Product Change Notification

PCN-AS-5652-2020

The hardware will be revised to safeguard availability of the ILC 1x1-series controller family. As a part of this revision, the CPU clocking frequency will be increased to 96 MHz for devices from hardware version 03. Firmware version 4.70 has been issued to support the new hardware. This firmware can only be installed and used in devices from hardware version 03. PC Worx projects that were created for earlier firmware versions are compatible with firmware version 4.7. As a part of the hardware revision, the internal battery for buffering the real-time clock has been replaced with a capacitor. Therefore, the system variable RTC_BATTERY_LOW will no longer be supported. We will implement this change at very short notice to safeguard availability of the ILC 1x1-series controller family.

Identifying characteristics

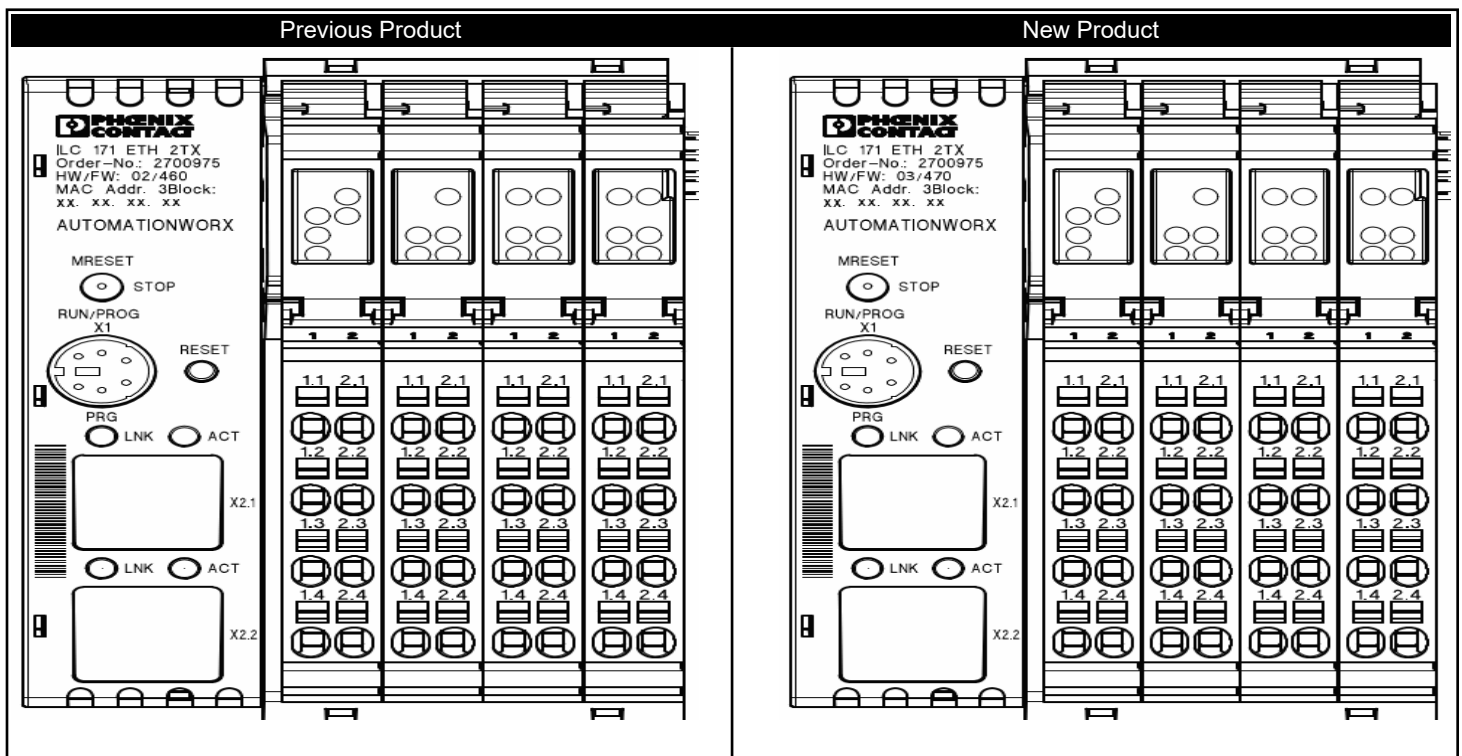
The hardware and firmware versions will be increased.
